STATE OF UTAH  
NATURAL RESOURCES  
Oil, Gas & Mining

RE: Revision Request for Diversion Ditch Dated August 21,  
1984, Natomas Coal Company, Trail Mountain Mine,  
ACT/015/009, #3, Emery County, Utah

RE: Diversion Ditch

Figure 1.. Trapezoidal diversion cross-section to be used in runoff control for the Trail Mountain Mine.

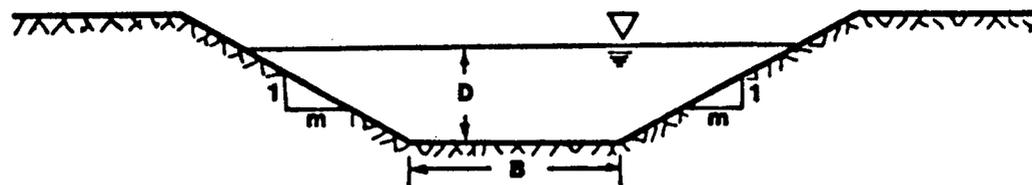
Division Hydrologist John Whitehead has reviewed your proposal, and as he has discussed with you, some problems exist. The primary one being the practicality of riprapping a disturbed area ditch which would need to be cleaned periodically. On October 11, 1984, you met with John and Tom Munson on-site to discuss the alternative measures for this ditch. The possibilities of asphaltting or concreting the stretch of ditch identified in your revision request were discussed. At present, the Division awaits your response to these alternative suggestions. No further action will be taken on this matter until we hear from you.
